# THE RESERVE AT CORRAL BLUFFS FILING NO. 2

RESERVE AT CB FIL 2.DWG  
MAY 3, 2018  
PROJECT 11032  
SHEET 1 OF 1

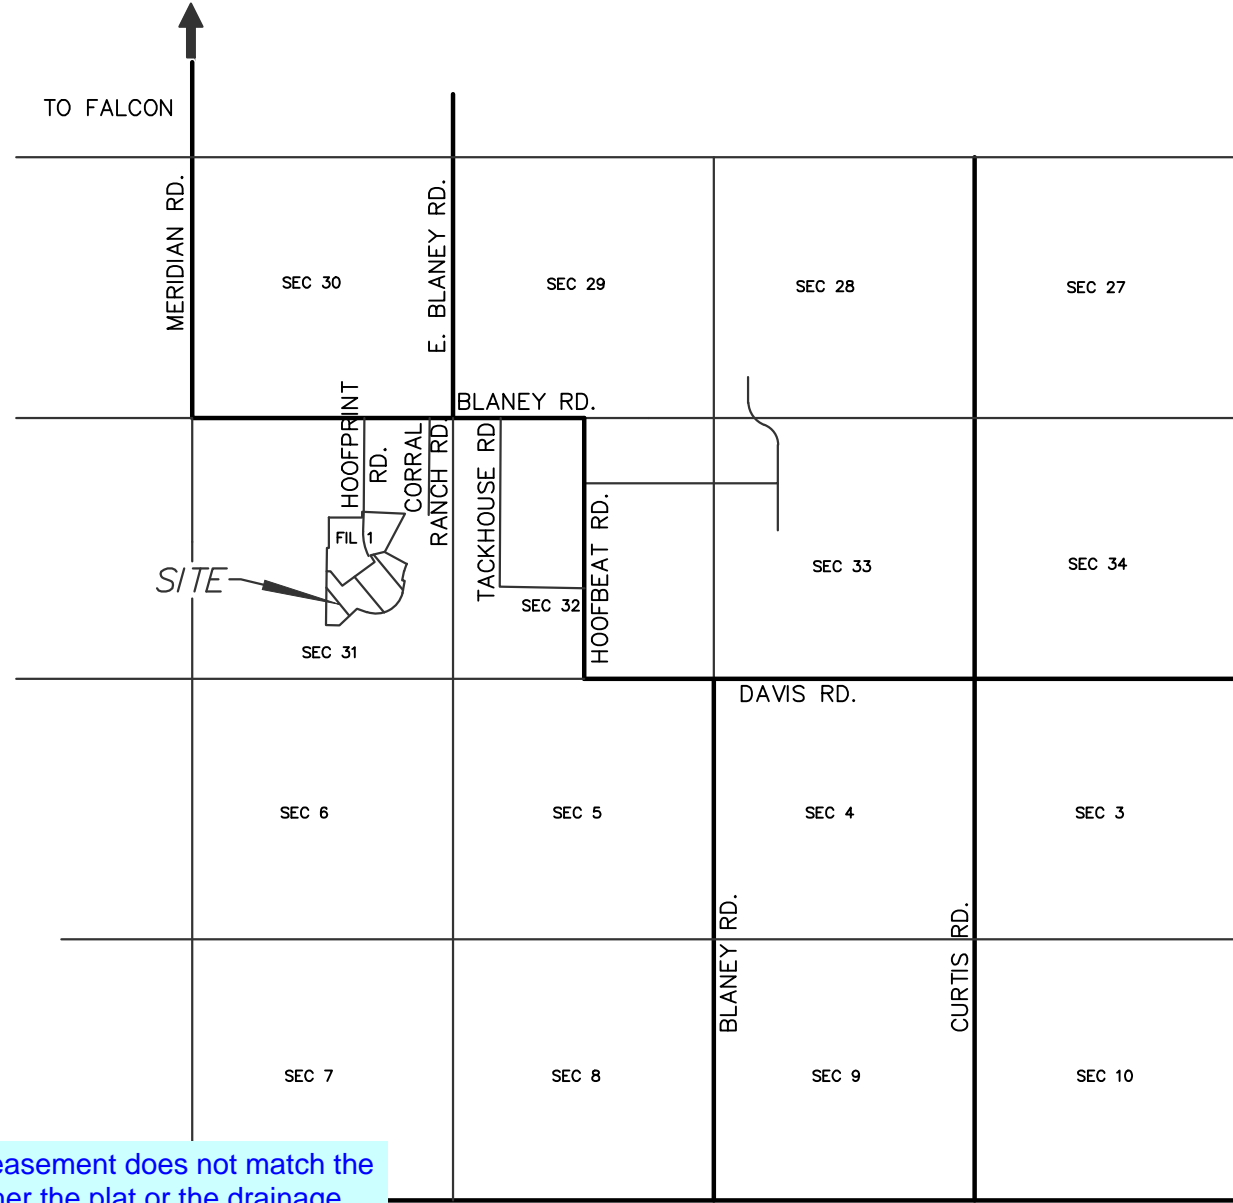
Alignment of the drainage easement does not match the drainage report. Adjust either the plat or the drainage map so both documents match.
